# **EVALUATION OF HIGH TEMPERATURE GAS COOLED REACTOR FUEL PARTICLE COATING FAILURE MODELS AND DATA**

**Office of Nuclear Reactor Regulation  
U. S. Nuclear Regulatory Commission**

Michael Tokar

Core Performance Branch  
Division of Systems Safety  
U. S. Nuclear Regulatory Commission  
Washington, D. C. 20555

Figure 28 TRISO Particle Coating Failure

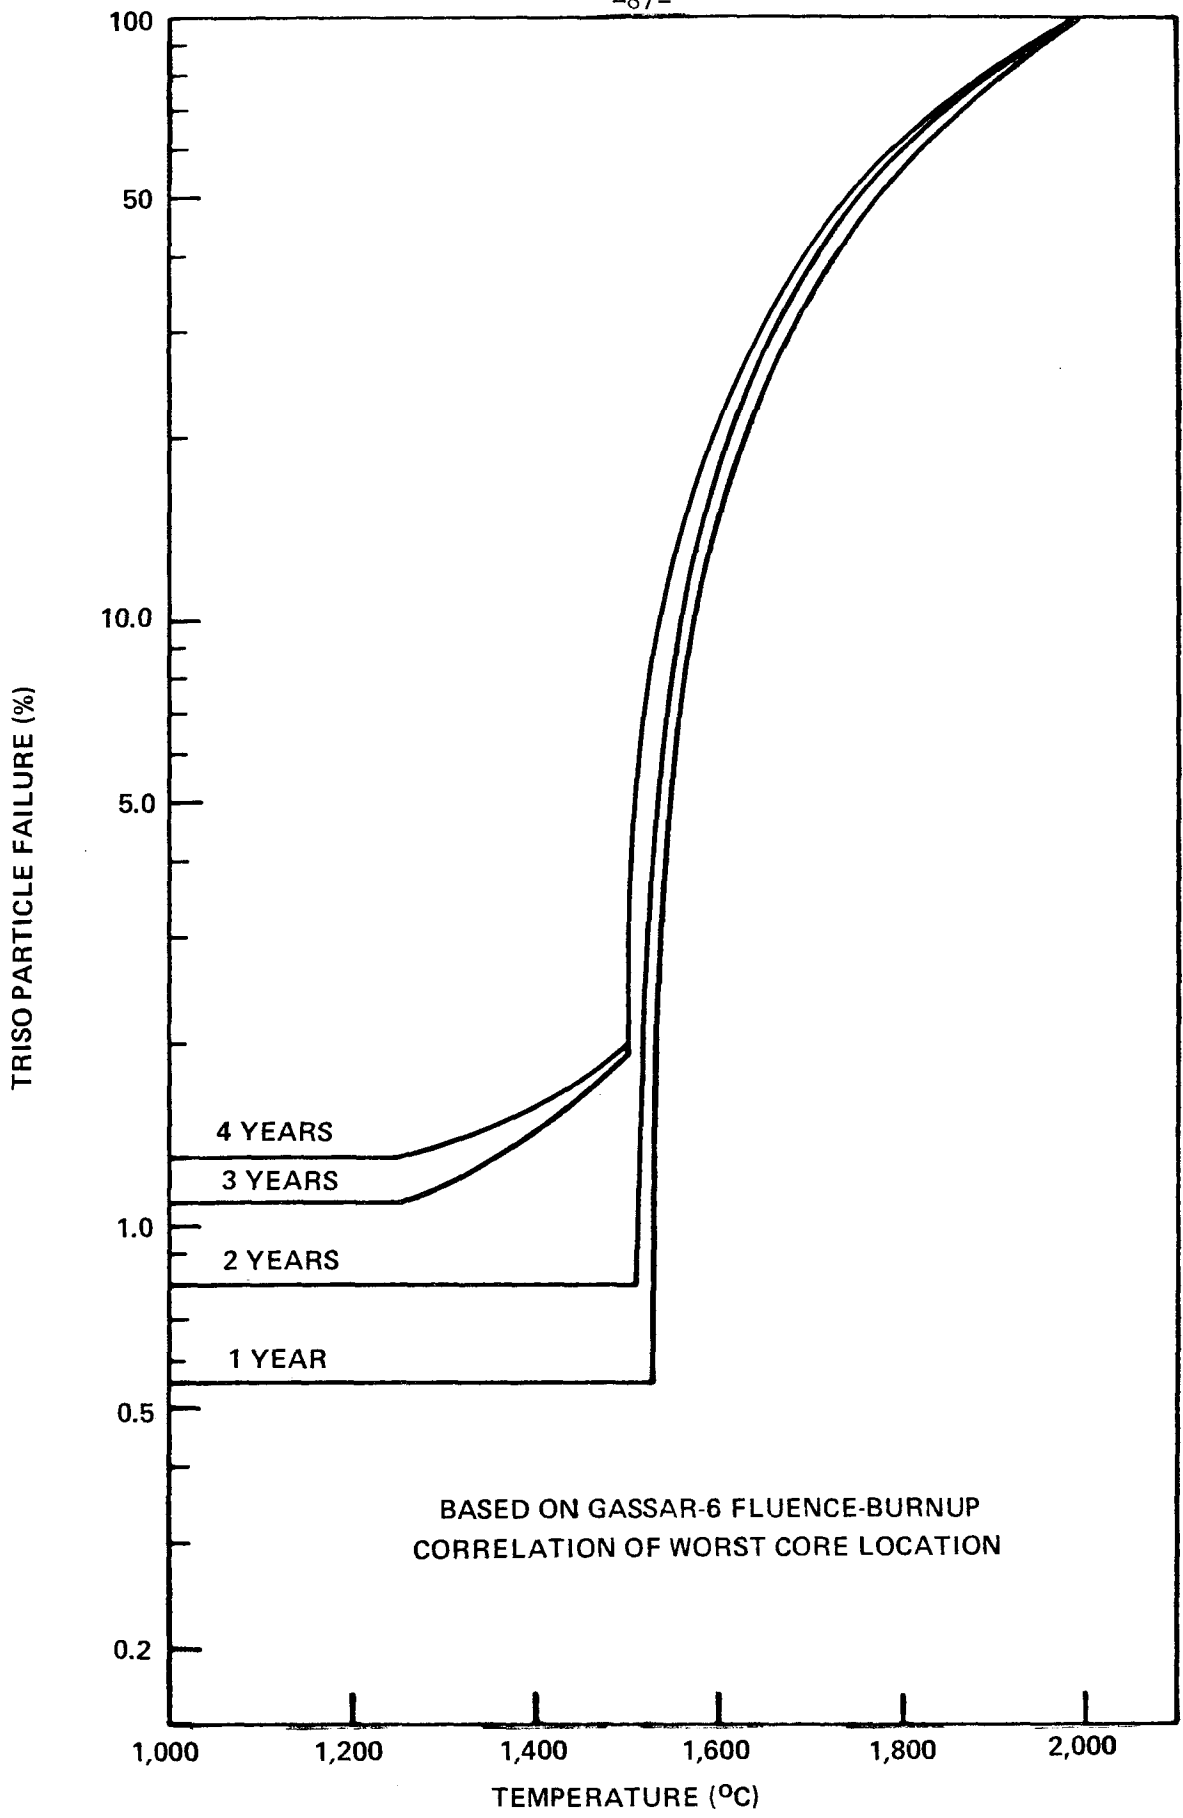
The horizontal portions of the curves for each fuel age shown in figure 28 were obtained from the sums of the failed fuel fractions for defective and off-specification fuel (see Sections III.A and IV.A). The defective fuel fraction is taken as 0,3% at BOL. Since a minimum failed fuel fraction due to off-specification fuel at temperatures  $\leq 1250^{\circ}\text{C}$  is taken to be 0.25%/year, the 1, 2, 3, and 4-year defective and off-specification fuel failure fractions are 0.55, 0.80, 1.05, and 1.30, respectively.

For estimates of pressure vessel failure at temperature  $>1250^{\circ}\text{C}$ , figure 19 was used along with the fluence and burnup values for each fuel age, provided in Table IV. For example, from Table IV it is seen that 3-year-old TRISO fuel at the worst core location has a fluence of  $6.2 \times 10^{21} \text{ n/cm}^2$  and a burnup of 77% FIMA. From figure 19 it is seen that at  $1500^{\circ}\text{C}$  (interpolating between the  $1425^{\circ}\text{C}$  and  $1600^{\circ}\text{C}$  curves), the plot of particle failure vs fluence yields a value of  $\sim 0,7\%$  at  $6.2 \times 10^{21} \text{ n/cm}^2$ , whereas the plot for failure vs burnup yields a value of  $\sim 0.8\%$ . Taking the higher value (0.8%) and multiplying by 2 (to account for the fact that GA assumed that only 50% of the TRISO particles having SiC layer stresses of 30,000 psi would fail), one obtains a pressure vessel failure value of 1.6% at  $1500^{\circ}\text{C}$ . Adding 0.3% for defective fuel to this value yields the total fuel failure (neglecting amoeba effects) of 1.9% for 3-year-old fuel at  $1500^{\circ}\text{C}$ . For 1- and 2-year-old fuel the failed fuel fraction is shown to remain essentially constant until a temperature is reached where SiC-fission product interaction becomes important, because the pressure vessel failure value obtained from figure 19, when added to the defective fuel value, is not greater than the assumed

The fuel particle failure curves show a very rapid increase in failure with temperature at the so called "critical" temperature, where SiC-fission product interaction becomes readily detectable. This temperature is obtained for each fuel age from Eq. 6, which related the critical temperature to burnup. Using Table IV again to correlate fuel age with burnup, one obtains a critical temperature of 1532, 1510, 1502, and 1500°C for 1, 2, 3, and 4-year fuel, respectively. The increase in fuel failure with temperatures above these "critical" temperatures is then obtained from figure 23. In the regime of SiC-fission product attack, the fuel failure is assumed to be incremental in the sense that a new increment of failure, to be obtained from figure 23, is added to the previous total for each 16 hours at temperature.

As shown in a comparison of the NRC-derived failure curves for TRISO fuel (Fig. 28) with the GASSAR-6 curves (Fig. 6), the curves have the same shape and form, as could be expected since the fundamental basis for the curves is the same. The major difference in the sets of curves, other than the slightly higher failure rates in the NRC-modified model at or near normal operation temperature, is the temperature at which there is a rapid increase in failure rate (due to the effect of SiC-fission product interaction). In the GASSAR-6 model, this occurs at roughly 1600-1650°C whereas in the NRC-modified model the rapid increase in failure rate occurs at approximately 1500°C. Hence, although the NRC-modified failure rates are more conservative than GASSAR-6, the difference is small when compared to the difference between this latest NRC proposed model and the original GA model shown in figure 1, or the early NRC-modification of figure 1 (which assumed, for example, that all the 4-year-old fuel failed at ~1020°C). If all other considerations remain unchanged, therefore, and also if the remaining portions of the GA model for fission product release are accepted (including dispersal from the particles, transport through the graphite, etc.), the fission product release from

Figure 29 BISO Particle Coating Failure

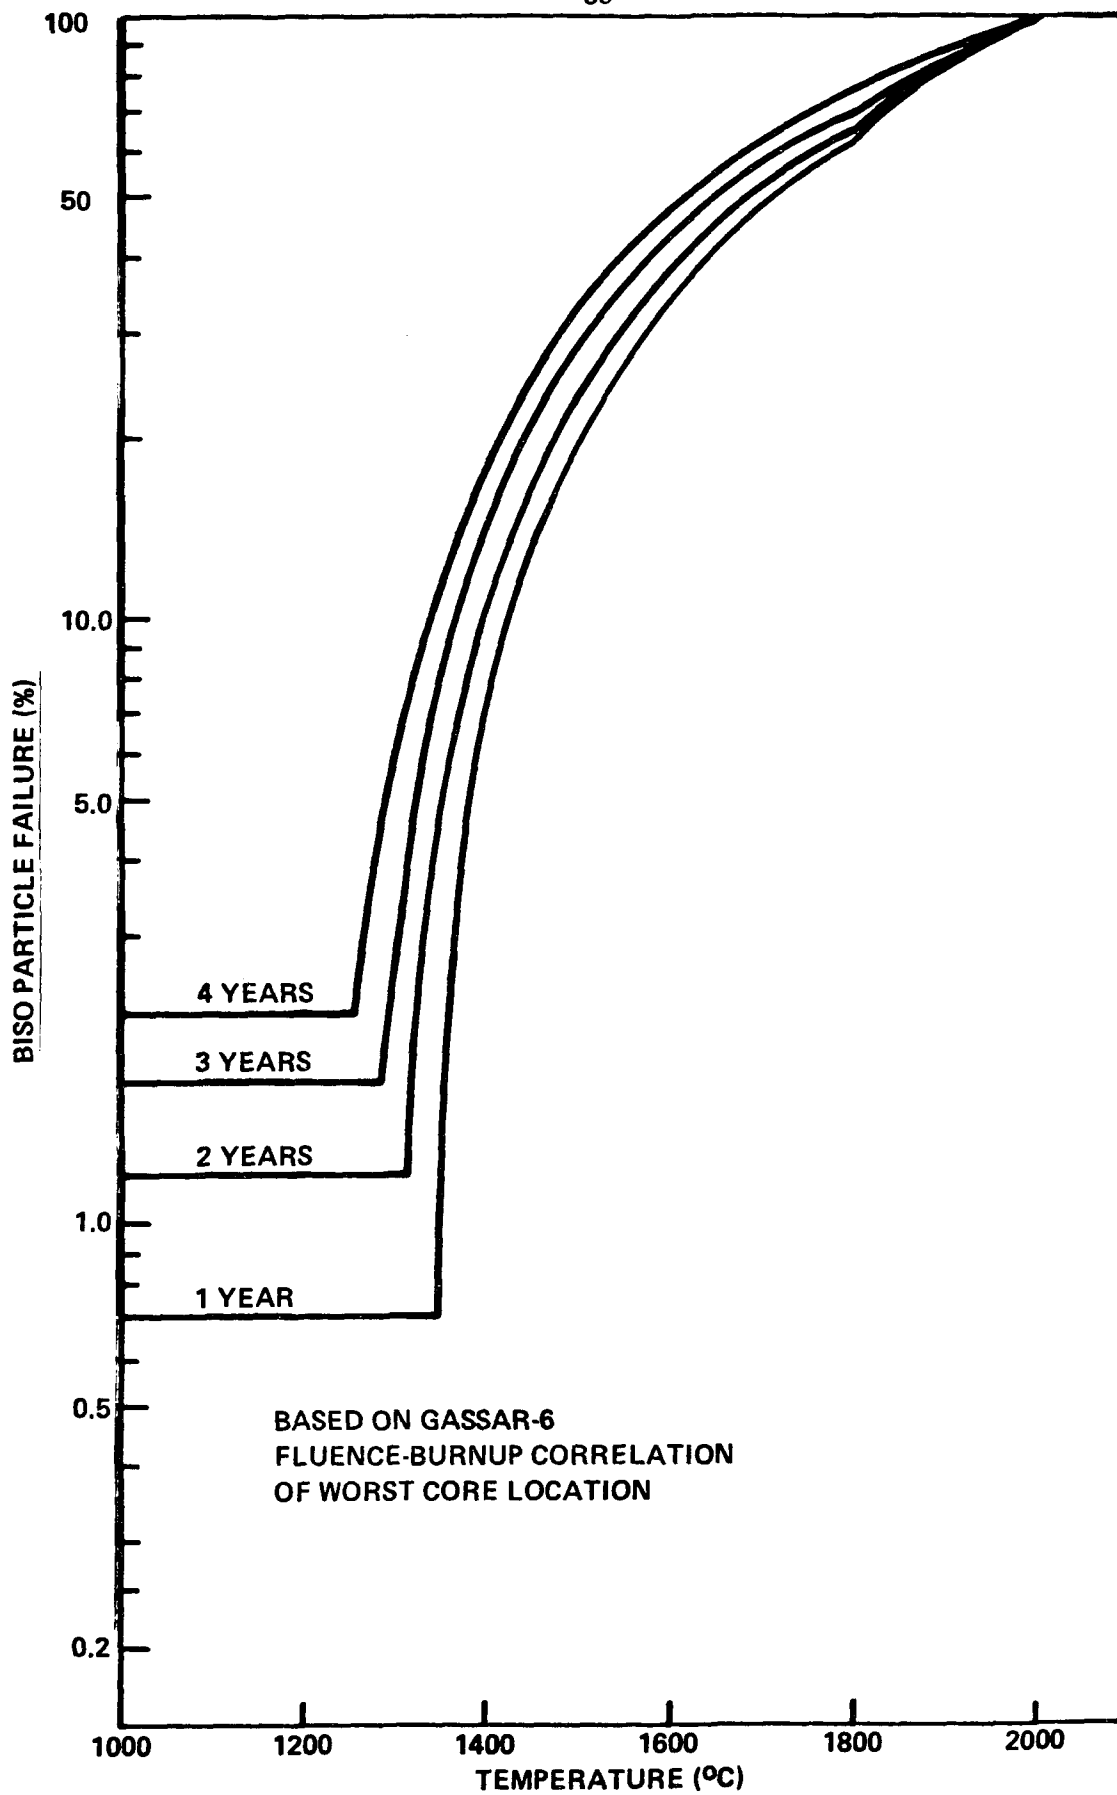
The curves for BISO ThO<sub>2</sub> fertile particle failure as a function of age and temperature are shown in figure 29. As with the TRISO fuel, the horizontal portions of the curves represent the totals for defective fuel plus off-specification fuel. As indicated in Sections III.B and IV.B the defective fuel fraction is assumed to be 0.2% at BOL, according to the proposed NRC model. The off-specification fuel is assumed to fail at the rate of 0.5%/year.

The assumed incremental BISO ThO<sub>2</sub> particle failure fraction is then obtained from figure 27. Since only the 1 year fuel has <2.5% FIMA burnup (as indicated in Table IV), only the 1 year fuel maintains a constant failure rate to 1350°C. The increment in failure, at temperatures above the constant failure rate line, is added to the previous total to get the "instantaneous" failure rate for BISO fuel.

Fig. 31. Effective Failure Fraction Versus Fuel Age

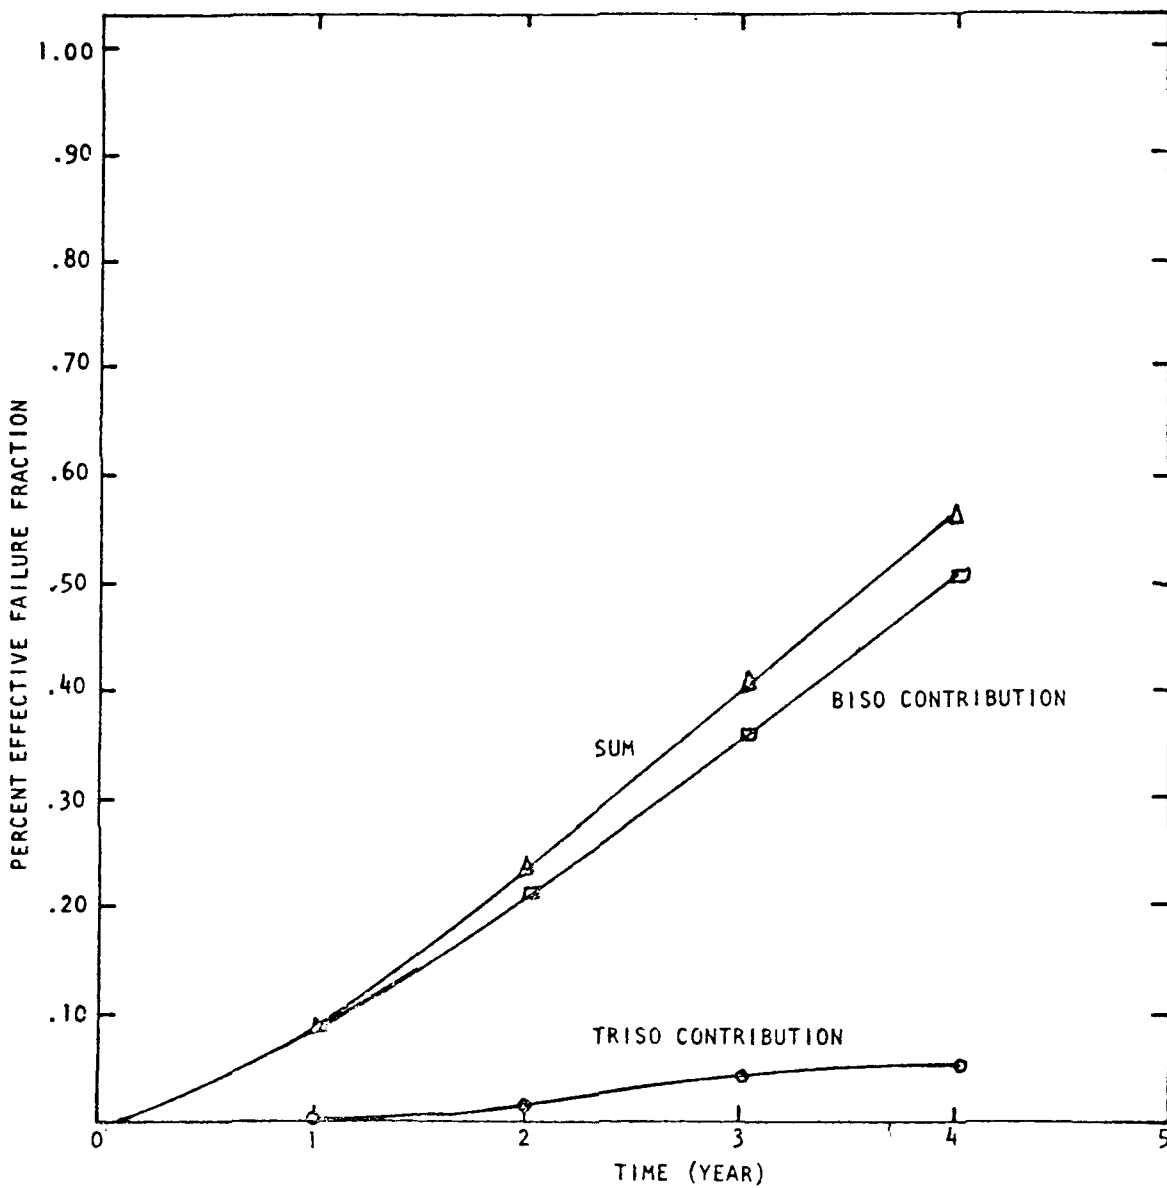
The calculation of failed fuel fractions to be used to determine primary coolant source terms is further complicated by the introduction of fission weighting to determine an "effective core average failed fuel fraction." This concept, which is described in Section 11.1.1.5 of GASSAR-6 (Ref. 1) takes into account the fact that the fraction of fissions in TRISO versus BISO fuel changes during the lifetime in reactor. This is shown schematically in figure 30 for TRISO fuel; although the fraction of fissions occurring in TRISO fuel is high at BOL, the fraction of failed particles is low, and the resultant "effective core average failed fuel fraction," including the TRISO fuel contribution to this fraction will be low. This is illustrated in figure 31, which is a plot of effective failure fraction versus fuel age.

It should be noted that the curves in figure 31 were based on values of  $F_t$  (nvt) which were obtained from an "old" GA fuel failure model (Ref. 8) which resulted in assumed pressure vessel failure fractions which were approximately twice those for the present GA model (Ref. 1) for temperatures  $\leq 1250^\circ\text{C}$ . Use of the new GA fuel failure model would reduce the effective expected fuel failure fractions somewhat. On the other hand, utilization of the proposed NRC guidelines for fuel failure, as illustrated in figures 28 and 29, would result in higher values for effective failed fuel fraction than shown in figure 31. This could have an effect on some aspects of accident analysis and design of some plant components, since as stated in Section 4.4.3 of the Fulton PSAR (Ref. 9), "accident analysis and plant system design are based upon a continuous core average failed fuel fraction of 2.68%". This value of 2.68% as previously stated, is 10 times the GASSAR-6 "expected" continuous core failed fuel fraction (effective) value. Multiplying the "expected" effective core average failed fuel fraction, obtained through use of the proposed NRC guidelines, by a factor of 10 might result in a higher design value than 2.68%, but the impact of this change has not yet been evaluated. Nor has it been established that the "factor of 10" is a necessary or proper approach to conservatism in establishing design values for fuel failure, accident analyses or plant system design.
